## DESIGN REVIEW COMMISSION MUNICIPAL CENTER COUNCIL CHAMBERS

Tuesday, July 27, 2010 6:00 p.m.

# a. Regency Homebuilders – 1364 Cordova Cove: Request Approval of a Wall-Mounted Tenant Identification Sign.

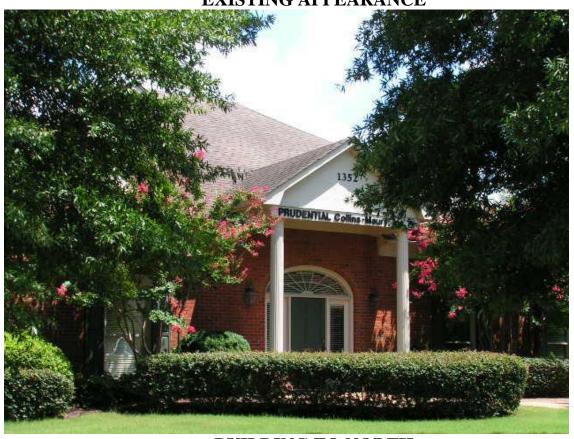
- 1. When the DRC approved the sign for the previous tenant (OR Nurses), it required the entire sign, text and logo, to be on the fascia board, in order to be consistent with signs on nearby buildings. Photos of the subject building and nearby signs are attached.
- 2. If approved, the applicant must obtain a permit from the Memphis / Shelby County Office of Code Enforcement prior to installing the signs.

<u>PROPOSED MOTION:</u> To approve the request for a wall-mounted tenant identification sign for Regency Homebuilders at 1364 Cordova Cove, subject to staff comments.
